**Water Filtration Plant
Town of Harrison, New York
Response to Comments on the Draft Scope For
the Draft Environmental Impact Statement (DEIS)**

Westchester Joint Water Works

Draft Scope Filing Date:	March 23, 2021
Scoping Hearing Date:	April 13, 2021
Last Date to Submit Comments:	May 10, 2021

Figure 1: Map depicting Shaft 20, Town of Greenburgh, and Shaft 22, City of Yonkers. Source: WJWW, 2019

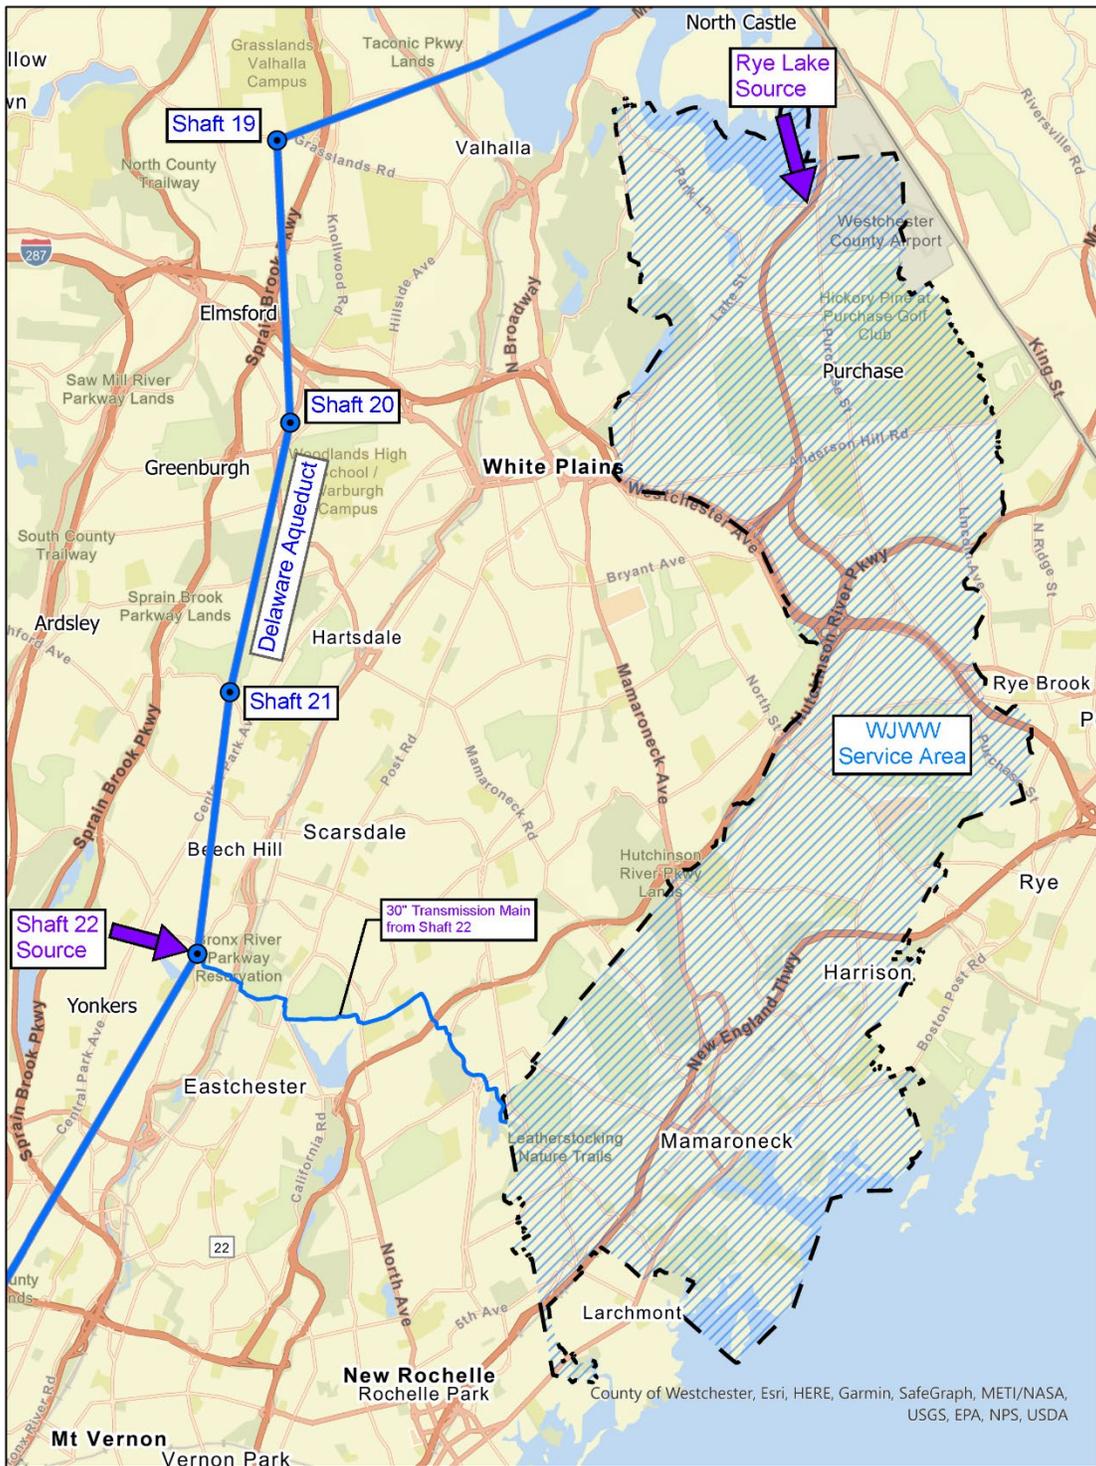
The description of the Proposed Action provided within the DEIS Draft Scope is insufficient because it is too general and vague. The description of the Proposed Action should identify why the alternative solutions considered to address the deficiencies in water treatment raised in the June 9, 2004, Judgment and Order and USEPA Administrative Order are not feasible. At the very least, these alternatives should be considered as alternatives in the Final Scoping Document and studied in the DEIS. In addition, a complete cost analysis of the other proposed alternatives available that the WJWW determined needs to be included in the Final Scoping Document and studied in the DEIS to ascertain whether the construction of a pipeline for conveyance of treated water directly from New York City's Shaft 20 in Yonkers was appropriate or practicable.

The Draft Scope identified several alternatives to be studied in the DEIS. In response to public comment, five Alternatives (numbered 5-9 in the Final Scope) have been added to the scope for the DEIS, including the construction of a pipeline from New York City DEP Shaft 20 in Greenburgh, NY (Alternative 9 in the Scope). It should be noted that the Draft Scope contained an error in referring to a Shaft 20 in Yonkers; Shaft 20 is located in the Town of Greenburgh (see Figure 1). This error has been corrected in the Final Scope.
